Installation of floodlighting facility (6 X 15 metre Columns) to an existing football pitch

Ref: P2024/0598

Response to initial comments:

Extract taken from Rev D

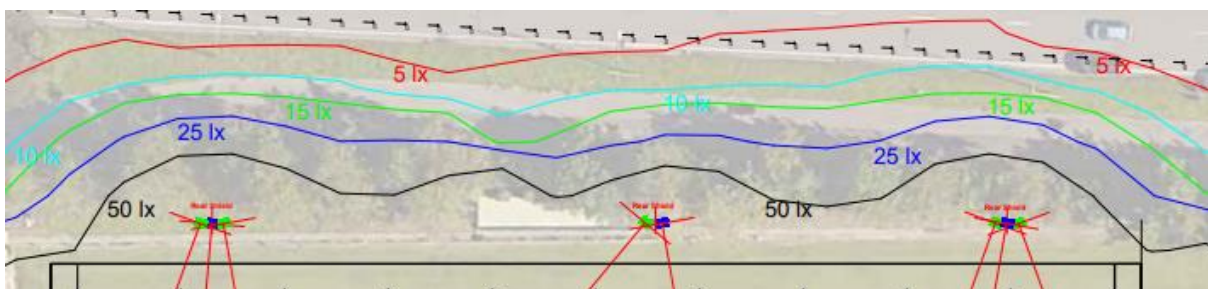
- 1. With regard to biodiversity issues our ecologists have some concerns regarding the lux levels along the tree lines and have commented that you should be aiming for lux levels of 5 or below along the tree lines to avoid impacts on potential bat flight lines.*
- 2. Environmental Health have requested that a lighting impact assessment be submitted. This has been requested as "this will take account of the current lighting situation and the impacts of the proposal. The assessment should talk us through what these plans are actually showing and provide some comparison of the proposed light levels against acceptable standards"*

Roadside Treeline

To mitigate the overspill issue we have encountered; we have added rear shields to every floodlight as well as included WSTB fittings on the masts located at the top of the pitch. The 5 Lux contours on the roadside have been brought in from middle of the road to the curb side of the road, which has resulted in the 5 Lux overspill being brought in by roughly 12m. Whilst we can demonstrate we are mitigating overspill it would be impossible to totally eliminate it and bring the lux levels down to 5 given the proximity of the treeline in relation to the proposed lighting column locations.

Extract taken from Rev D

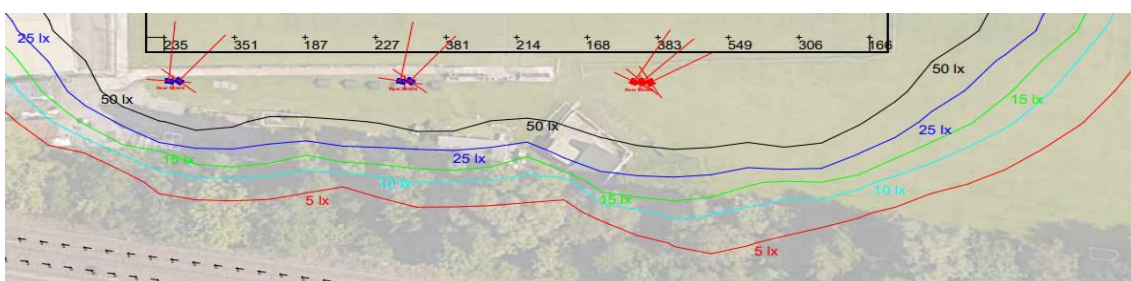
Trackside Treeline

To mitigate the overspill issue, we have encountered; we have added rear shields to every floodlight. The majority of the trackside treeline remains at the required 5 Lux which we are confident meets the ecologist requirements
